SERVICE BULLETIN

Service Bulletin No.: DA20-78-01, Rev. 1

Title: Exhaust System, Improved Joint Sealing

Figure 1.

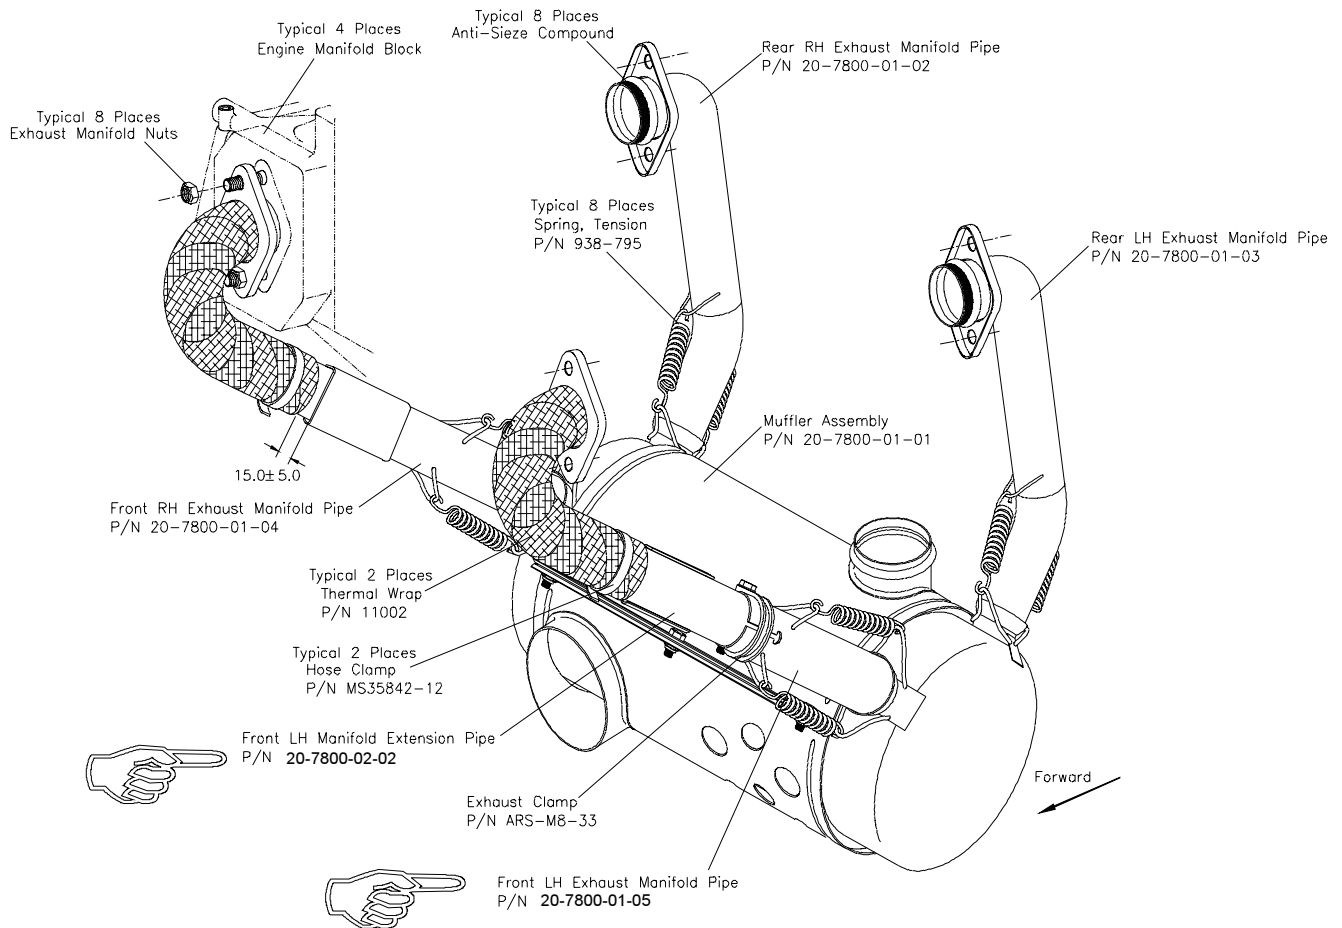
3. **General:** Exhaust leakage may occur as a result of misalignment or deformation of the exhaust joints. This bulletin specifies replacement of the existing exhaust system with a new variant, incorporating improved exhaust joint sealing.

- 10.2 Disconnect all ducting from the muffler shroud (Air Intake, Carb Heat, Heat Box). Unbolt the exhaust system from the engine, by removing the exhaust manifold nuts (ref. figure 1).

- 10.3 Use the tension springs (p/n 938-795) to attach the front RH exhaust manifold pipe (p/n 20-7800-01-04), the front LH exhaust manifold pipe (p/n 20-7800-02-02), and the rear RH and LH exhaust manifold pipes (p/n 20-7800-01-02 and 20-7800-01-03) to their respective positions on the muffler assembly (p/n 20-7800-01-01) (ref. figure 1).

- 10.4 Apply loctite anti-seize compound (p/n 76764) to all four (4) exhaust pipe ends, as indicated in figure 1. Bolt the above assembly (ref. paragraph 10.3) to the engine, and lightly tighten the exhaust manifold nuts as they are reinstalled.

- 10.8 Slide the exhaust clamp into position as shown in figure 1, and torque it down to 20 ft/lbs. Re-install all ducting connections to the muffler shroud (Air intake, Carb Heat and Heat Box).
